Access Compliance Report

Public Rights-of-Way

(Island Curb Cuts)

Intersection ID: 21102	Main Street: S_TRYON_ST	Cross Street: AYRSLEY_TOWN_BV	Location: W
ADA ID: 74B31B1B9324	Curb Cut Type: MedianRefuge2	Initial Pass/Fail: Pass	Overall Compliance: No
Codes/Mitigation Info/Possible Solution		Field Measurements/Component Compliance	
Severity Score: 0

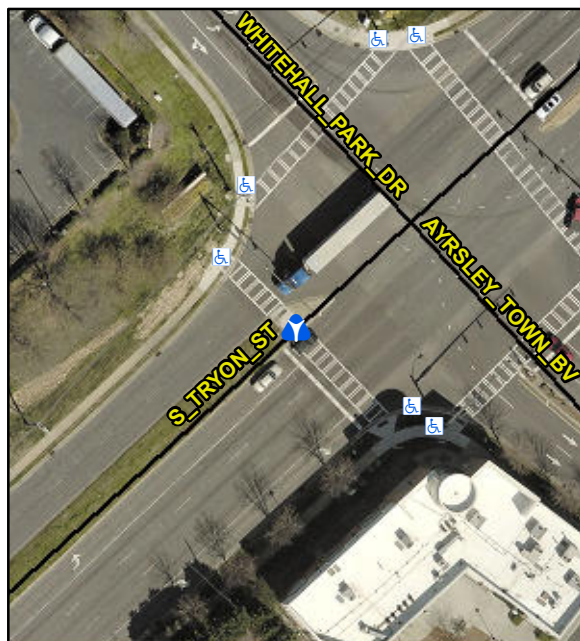
Compliance	Description	Data	Compliance	Description	Data
Yes	Refuge 1 Length (In)	90.0	Yes	Gutter 1 Ponding?	No
Yes	Refuge 1 Width (In)	101.0	Yes	Gutter 1 Lip Ht (In)	0.0
Yes	Refuge 1 Slope (%)	0.2	Yes	Gutter 1 Slope (%)	1.3
Yes	Refuge 1 X Slope (%)	1.5	Yes	Gutter 1 X Slope (%)	0.2
N/A	Painted X Walk1?	Yes	Yes	DWS 1 Provided?	Yes
N/A	X Walk 1 Direction	To SE	Yes	DWS 1 Contrast?	Yes
N/A	X Walk 1 Width (In)	112.0	Yes	DWS 1 Length (In)	24.0
N/A	Road 1 Slope (%)	1.7	Yes	DWS 1 Full Width?	Yes
N/A	Road 1 X Slope (%)	2.9	No	DWS 1 Offset (In)	9.0
Yes	Refuge 2 Length (In)	90.0	Yes	Gutter 2 Ponding?	No
Yes	Refuge 2 Width (In)	101.0	Yes	Gutter 2 Lip Ht (In)	0.0
Yes	Refuge 2 Slope (%)	0.9	Yes	Gutter 2 Slope (%)	2.0
Yes	Refuge 2 X Slope (%)	2.0	Yes	Gutter 2 X Slope (%)	0.2
N/A	Painted X Walk2?	Yes	Yes	DWS 2 Provided?	Yes
N/A	X Walk 2 Direction	To NW	Yes	DWS 2 Contrast?	Yes
N/A	X Walk 2 Width (In)	112.5	Yes	DWS 2 Length (In)	24.0

N/A	Road 2 Slope (%)	0.4	Yes	DWS 2 Full Width?	Yes
N/A	Road 2 X Slope (%)	2.5	No	DWS 2 Offset (In)	18.0
N/A	Refuge 3 Length (in)	N/A	N/A	Gutter 3 Ponding?	N/A
N/A	Refuge 3 Width (in)	N/A	N/A	Gutter 3 Lip Ht (in)	N/A
N/A	Refuge 3 Slope (%)	N/A	N/A	Gutter 3 Slope (%)	N/A
N/A	Refuge 3 XSlope (%)	N/A	N/A	Gutter 3 XSlope (%)	N/A
N/A	Painted X Walk3?	N/A	N/A	DWS 3 Provided?	N/A
N/A	X Walk 3 Direction	N/A	N/A	DWS 3 Contrast?	N/A
N/A	X Walk 3 Width (in)	N/A	N/A	DWS 3 Length (in)	N/A
N/A	Road 3 Slope (%)	N/A	N/A	DWS 3 Full Width?	N/A
N/A	Road 3 XSlope (%)	N/A	N/A	DWS 3 Offset (in)	N/A
Yes	Any Obstructions?	N/A	N/A	Storm Grate/Utility Hazard?	No
N/A	Obstruction Type		N/A	Storm Grate/Utility Type	
		N/A			N/A
N/A	Surface Condition	Good

Possible Solutions:

Remove & Replace Detectable Warning System.
